HORTON ENGINEERING CHANGE NOTICE

ECN 1388

REPLACING THE SIDE ENTRY DOOR GAS SPRING/ SHOCK

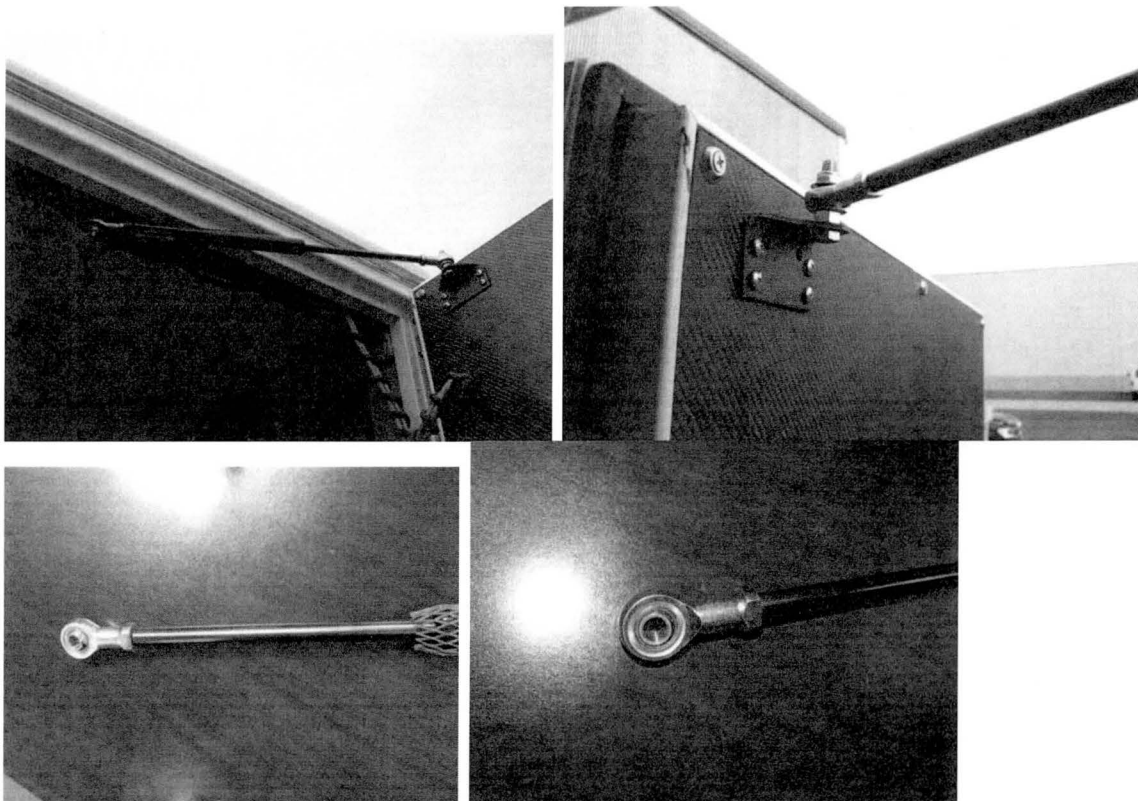
This ECN is for changing the standard Suspa side entry door gas spring PN 10009821 to Suspa (C16-31016) PN 10012912. We have been experiencing some failures with the current gas spring on side entry doors. The current fixed clevis (NYC Style) is breaking and some of the shafts are bending. To correct the problem, we designed a new gas spring with thicker shaft 0.390" and larger cast clevis. In addition, the new clevis is a swivel style and will relieve any additional angle stress on gas spring. The new design will provide better support for our side entry doors and will compensate for angle variation in the install process. See attached pictures for the new gas spring. (Field retrofit will require bracket relocation on door jamb and new lower close out board, use same brackets and hardware)
